WELL TEST ANALYSIS

Project: 42562

Location: Stevens County

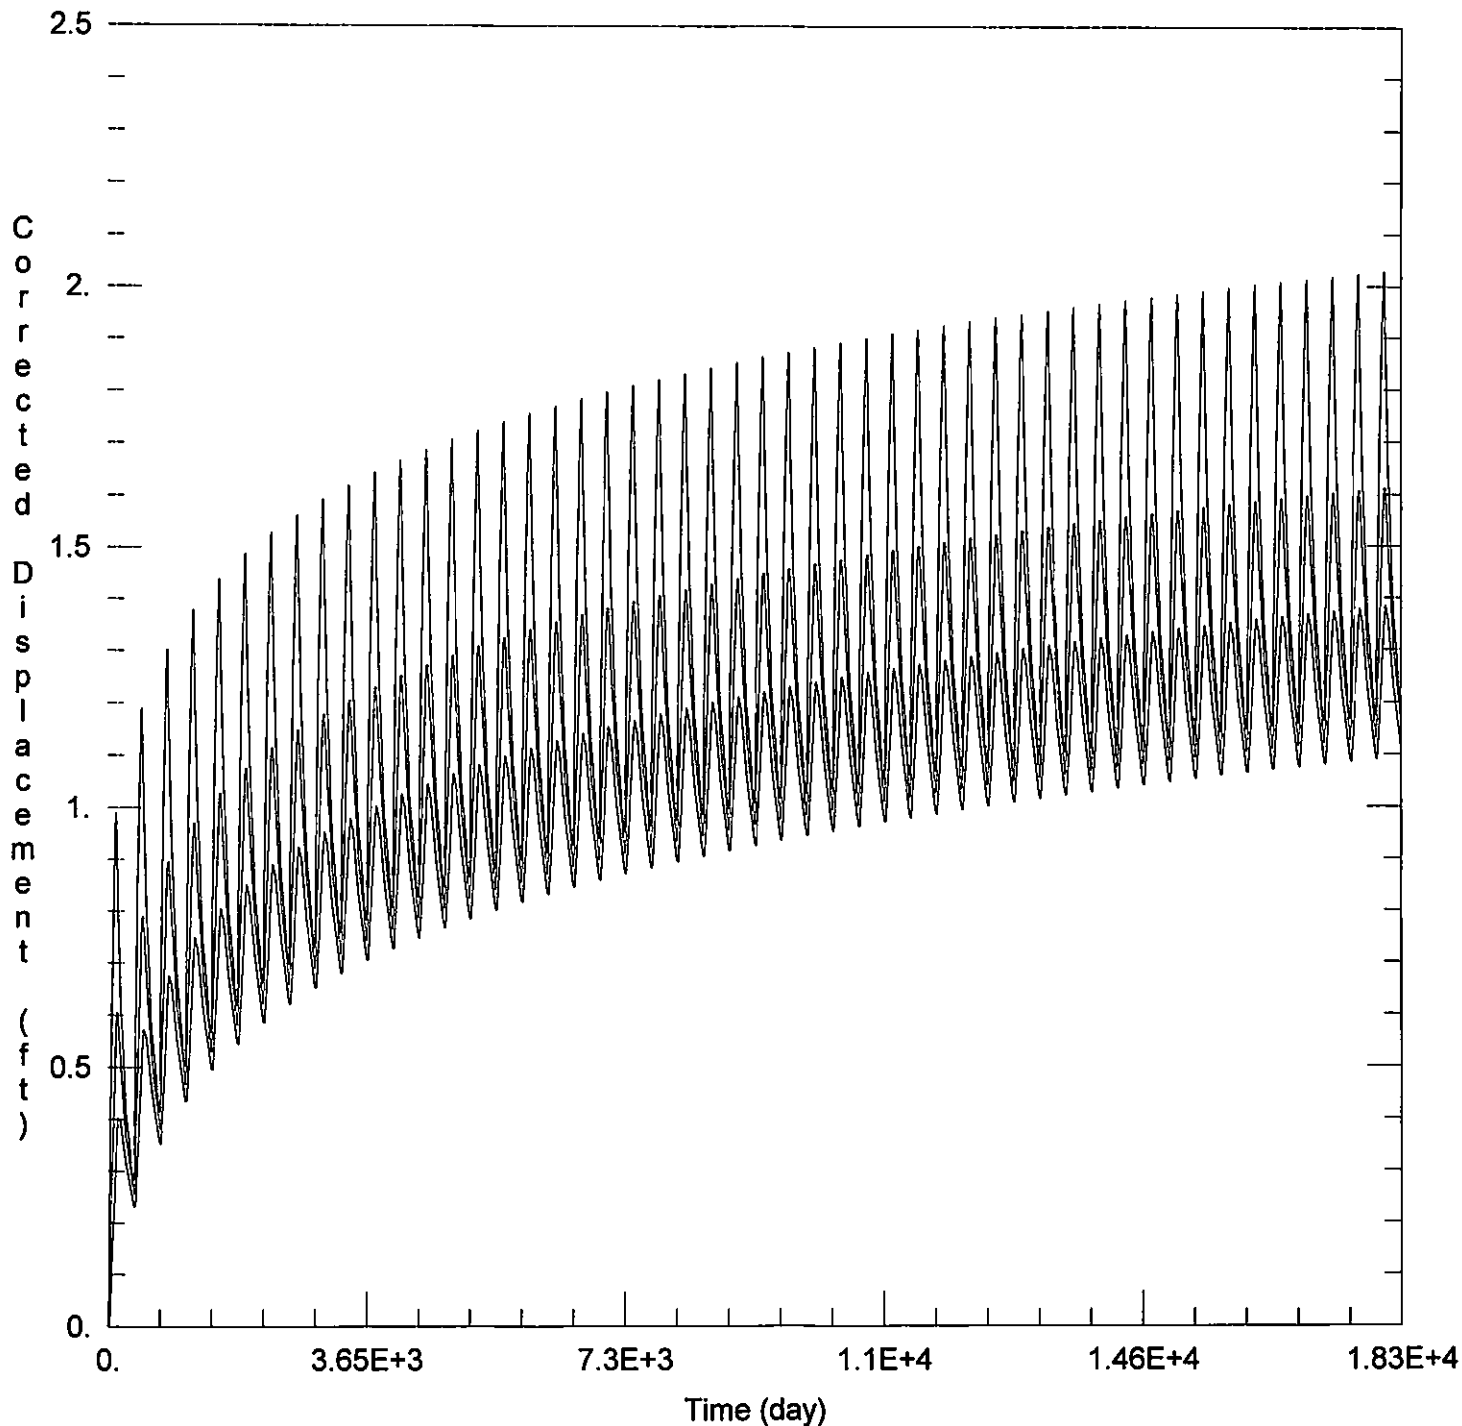
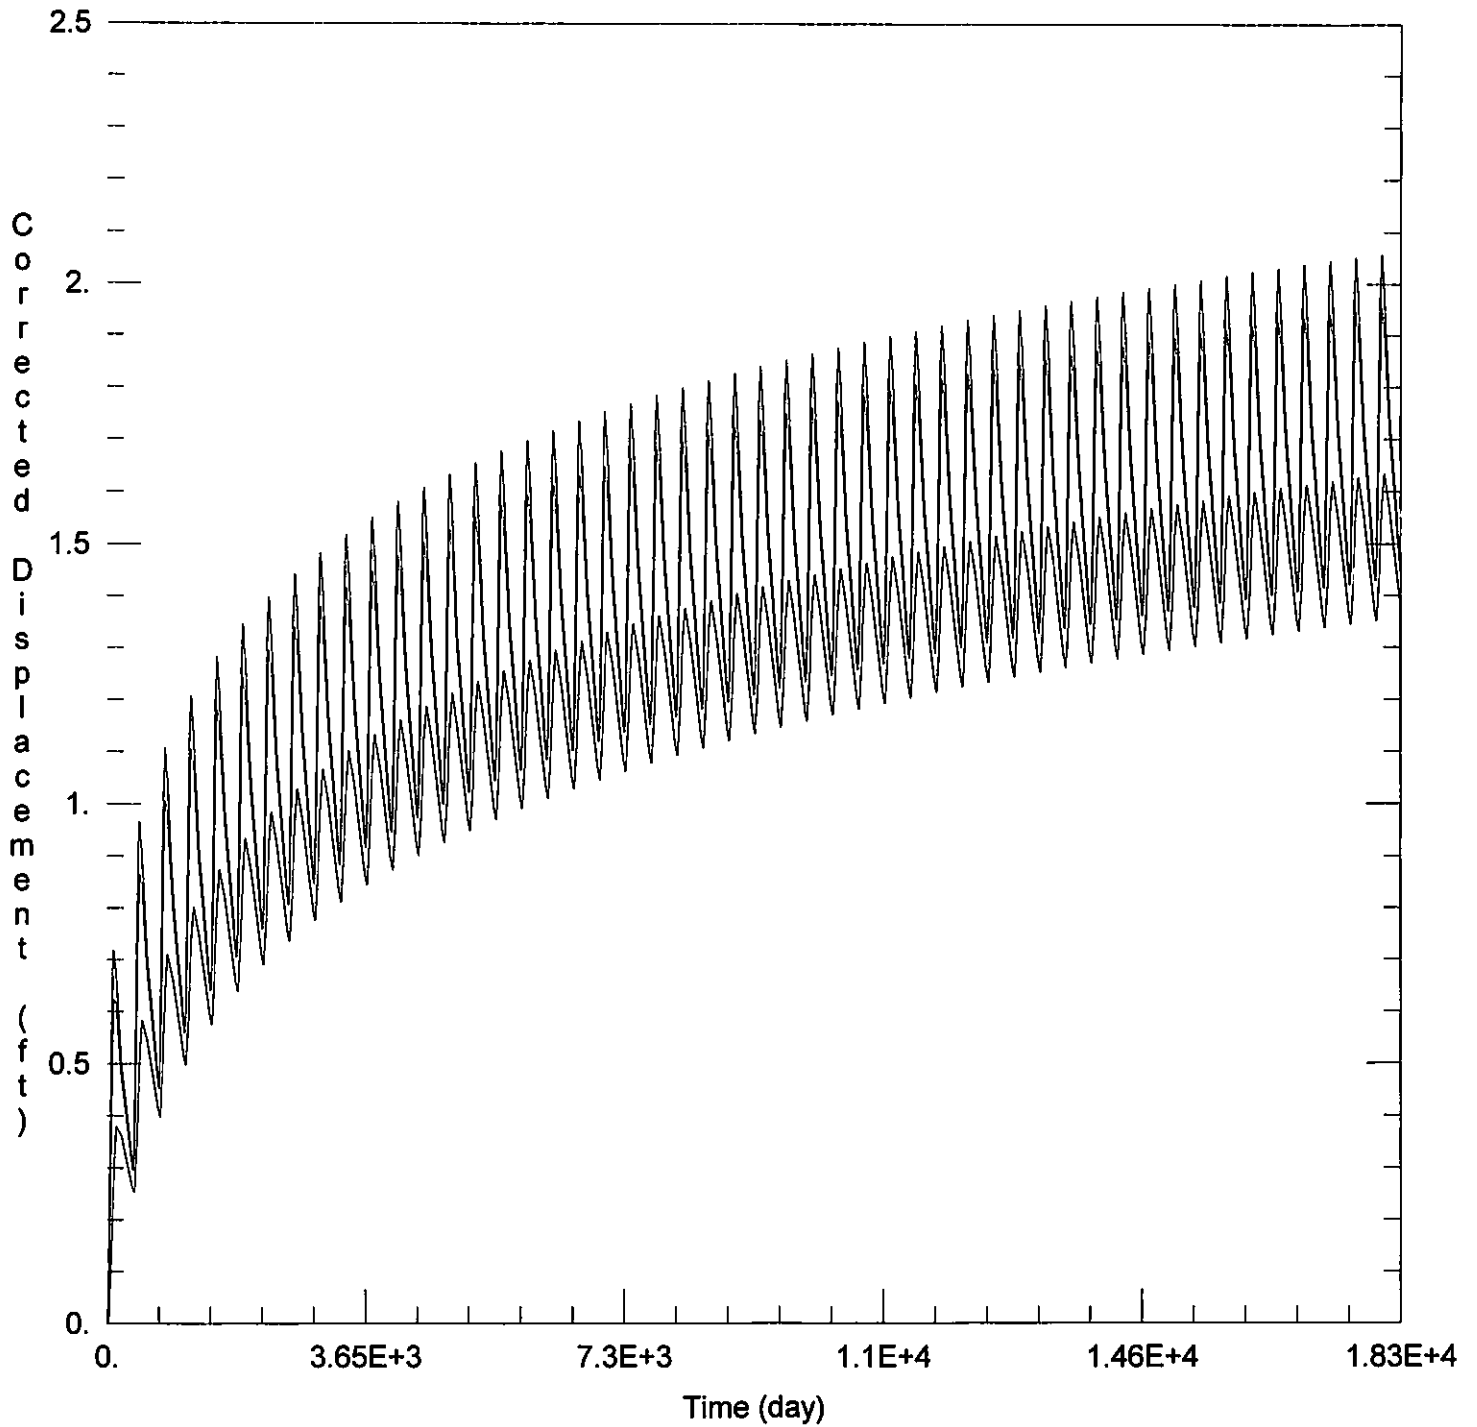
Domestic 17-35-38: Drawdown from current location = 2.03 ft
 Drawdown from proposed location = 1.63 ft
 Net drawdown = -0.4 ft

Net drawdown does not exceed the drawdown allowance of 4.0 ft for any well within 1 mile of the proposed location. Therefore, critical well analysis is not necessary.

The proposed move is likely to create minimal effects on neighboring wells and appears unlikely to cause impairment. Any concerned neighbors should contact GMD3 at (620) 275-7147 or the Division of Water Resources at (620) 276-2901.
